SUBJECT: Forwards info re reactor vessel issues, per 900305 telcon concerning change of license expiration date.

Subject: Change of License Expiration Date  
Additional Information  
R.E. Ginna Nuclear Power Plant  
Docket No. 50-244

LICENSE AMENDMENT - CHANGE OF EXPIRATION DATE

Questions from March 5, 1990 NRC/RG&E Telecon

Figure 5.3-2

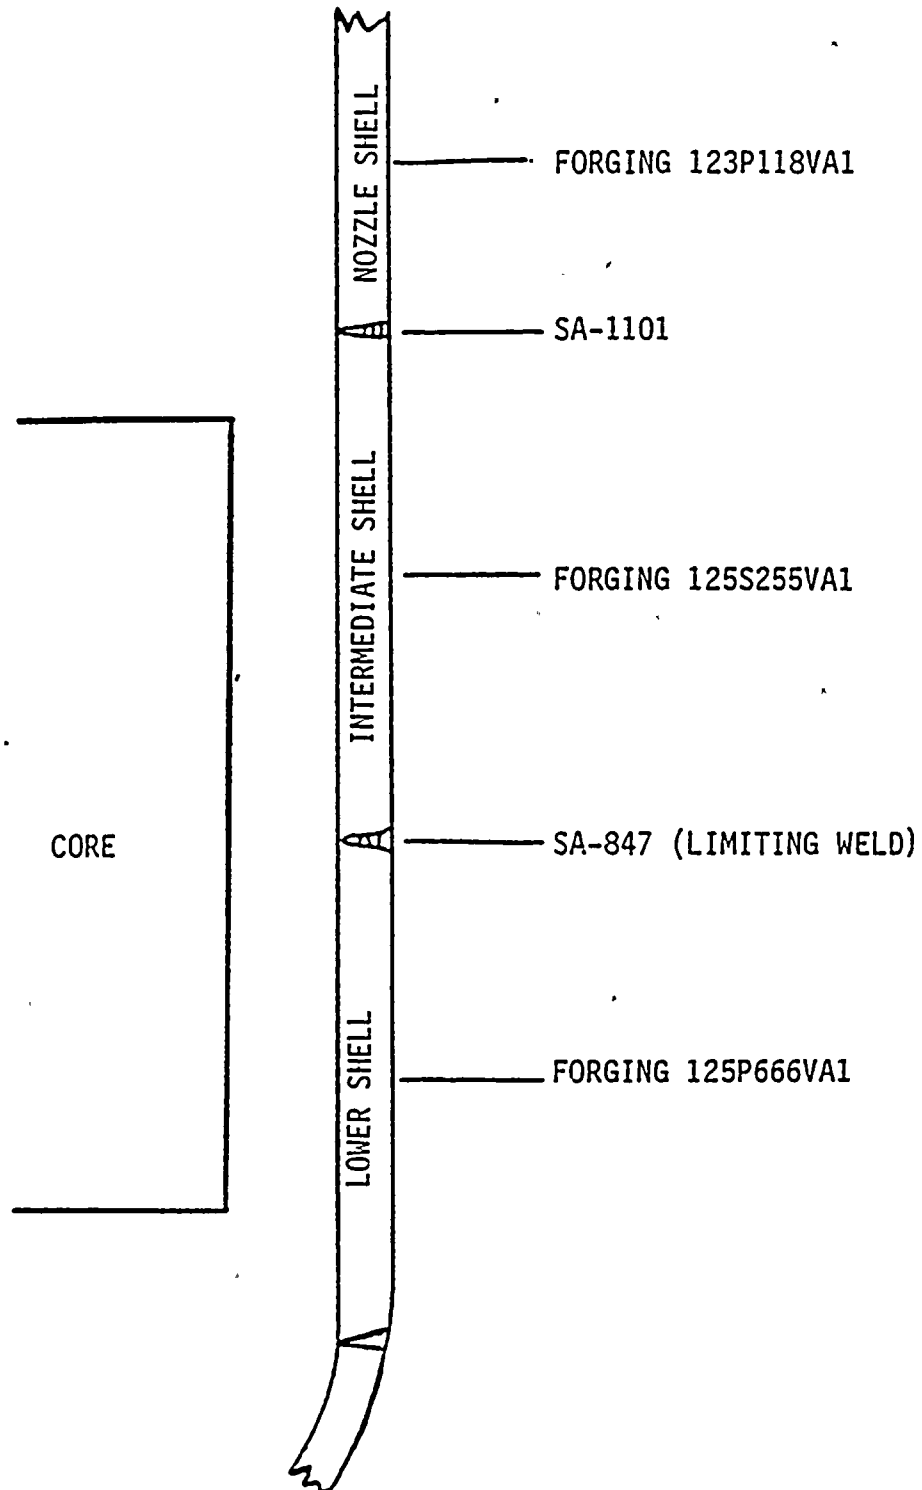
Page 4-1 of Capsule R Report appears to have the lower and intermediate forging numbers reversed.

### 7. Question

The sentence from Page 4-1 reads in part ...intermediate and lower shell forgings (heats 125P666 and 125S255).... This sentence is confusing and does have the numbers in the wrong order. This should read ...intermediate forging (125S255) and lower forging (125P666VA1).... The correct forging numbers are shown on Ginna UFSAR Figure 5.3-2, which is attached.

As stated in Section 5.3.1.2 of the Ginna UFSAR, the beltline weld, SA-847, is limiting. The location of this weld is shown on the attached Figure 5.3-2 of the Ginna UFSAR.
